Corrigendum - 2 dated 26/12/2025 to CPC Tender No. BHEL/CPC / YNR/EPC-CHP/ 26 /047

Corrigendum - 2 to Tender for the work of "EPC PACKAGE FOR COAL HANDLING PLANT and BIOMASS HANDLING PLANT along with RAILWAY SIDING WORKS AT 1X800 MW, SUPER CRITICAL EXPANSION UNIT, DCRTTP, YAMUNA NAGAR, HARYANA"

**A) Some of the Bidders had asked queries in the published tender specification. The clarifications issued by BHEL are furnished below:**

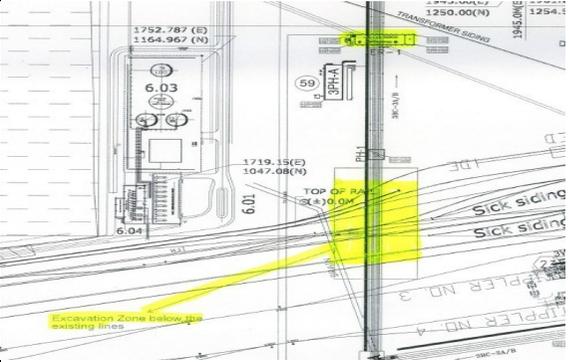
23.	TCC, CHAPTER-III, SCOPE OF WORK Clause-3.29	The CHP & BHP layout in the plot plan & flow diagram attached in annexure-4 are indicative

Sl. No.	Reference clause of Tender	Existing Clause	Bidder's Query	BHEL's Response
			the stock pile area and shed over it.	
24.	TCC -CHAPTER-III, SCOPE OF WORK Clause-3.18, Sl. No.: B-3	SCOPE OF BIDDER: - Complete Bull dozers, Pay loaders & Dumpers as applicable for Coal & biomass handling plant	<p>1. Quantity of earth moving equipment considered as shown in flow diagram i.e.,</p> <p>Dozer-4 Nos Pay Loader-3 Nos Dumper-2 nos</p> <p>2. Please indicate the delivery schedule of earth moving equipment.</p>	<p>Bidder to refer Time Schedule indicated for the completion of the major activities in Chapter-IV of TCC.</p> <p>Refer to clause no 4.4 of TCC Chapter-IV, Inputs exchange between the EPC vendor and BHEL in line with the scope defined. in the relevant annexures shall be progressive.</p> <p>Detailed L-2 Schedule and L3 Schedule, including inputs requirement dates from BHEL, shall be prepared and submitted by Vendor for approval of BHEL.</p> <p>To meet above schedule in general, and any other intermediate targets set, to meet customer/project schedule requirements, vendor shall arrange &amp; augment all necessary resources from time to time on the instructions of BHEL.</p>

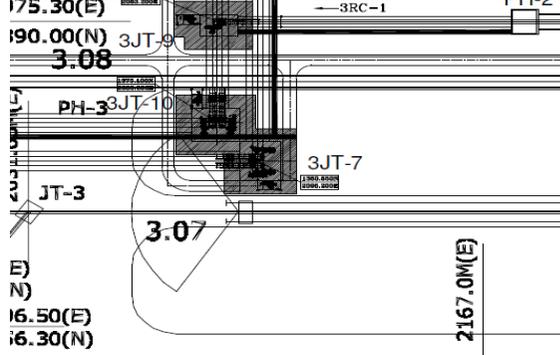
25.	Annexure-22 of TCC Railway Siding Work.	Actual location of railway siding and wagon tippers shall be as per approved railway siding drawing. In case of any change in location of wagon tippler mandated by railways, bidder to incorporate required corresponding changes in the CHP layout (i.e., routing of coal conveyors & other facilities) without any cost implication to BHEL	<p>Based on the feasibility study done by "Drongo Advisory Services Pvt Ltd", Northern railway HQ already has given approval of railway siding facility taking off from Kalanaur Station.</p> <p>Accordingly, rail lay-out, location of new wagon tippler complex (WTC-1) along with downstream conveyors, crushing screen arrangement,</p>	Tender Conditions Shall Prevail.
